Pre-planning enquiry: Confirmation of sufficient capacity

Site Address: The Mortlake Brewery

> Appendices The Former Stag Brewery, Mortlake Project Number: WIE18671 Document Reference: WIE18671-104-R-11-7-1-DS

From:	Katherine Wood <katherine.wood@london.gov.uk></katherine.wood@london.gov.uk>
Sent:	08 February 2019 17:12
То:	Nora Balboni; Stuart McTaggart; Abby Crisostomo
Cc:	Anna Gargan; Suzanne Robson
Subject:	RE: Stag Brewery (GLA ref: 4172a/b) drainage strategy

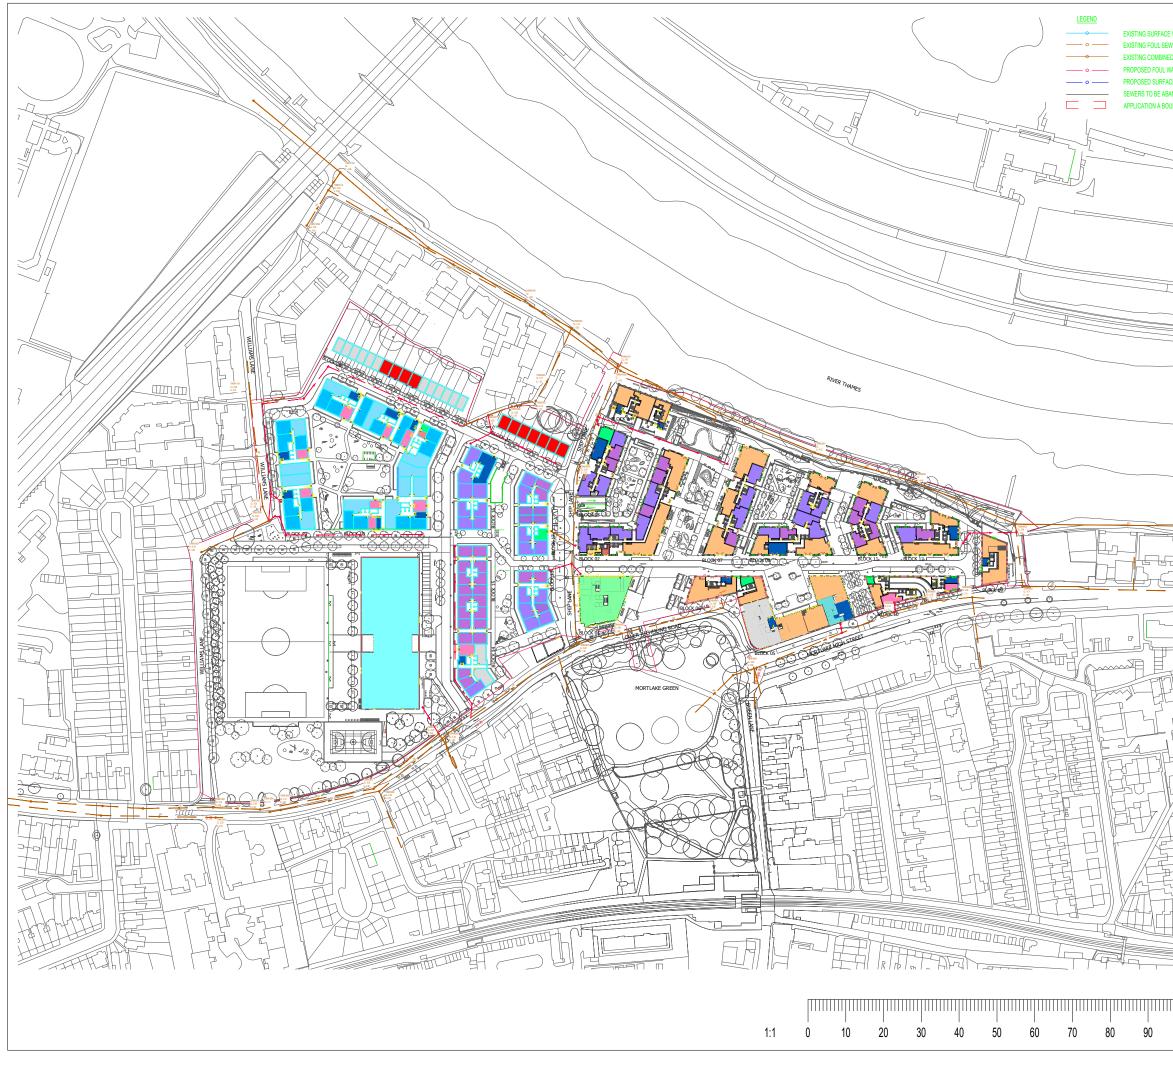
P04 S			ne req's refined to match source eable paving added to SW Catch		SW SW	SH BM		
	P03 5			ected annotation to match storage		SW	BM		
70	P01 S		ISSU	ED		SW	BM		
	Status	Date		Description		Ву	Chk		
				Amendments					
	Project Title					TER)		
	PROPOSED SURFACE WATER DRAINAGE STRATEGY								
	Client RESELTON PROPERTIES LIMITED								
	W waterman								
	Office Address Telephone & Fax numbers mail@watermangroup.com www.watermangroup.com Suitability								
	Designed	Ву		DORDINATION	Waterman Ref		51		
	Drawn By	Desig		BM	Scales @ A3	WIE18	3671		
ΠΠ			SW	Volume - Level - Type - Role		1:25 Revis			
 100	18671-WIE-ZZ-ZZ-DR-D-92001 P04
